Geotechnical Survey Report

**Williams Properties / Stonestreet Development
Louisville, KY**

Re: Geotechnical Survey Report
Williams Properties / Stonestreet Development
Louisville, KY

Figure 1 - Site Geology

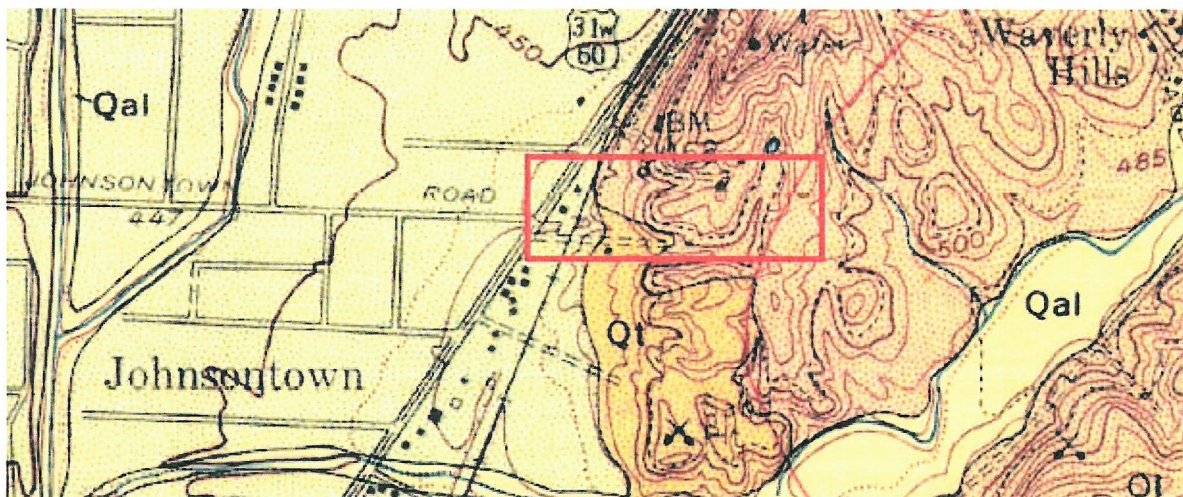
1. A full Geotech before the construction plans are done is recommended by the consultant and should be a BE.
2. The Loess soils on-site should have limited exposure during construction
3. Any New Providence Shale must have less than 24 hours exposure and no exposure to rainfall
4. There a drainage pipe in the northeast corner of the site that is at a very steep angle. It should be designed not to rise up and also have significant energy dissipaters at the outlet.
5. They are also recommending stabilizing the 2:1 slopes with turf reinforcement matting and using low maintenance vegetation. You may want to consider this for a BE also.
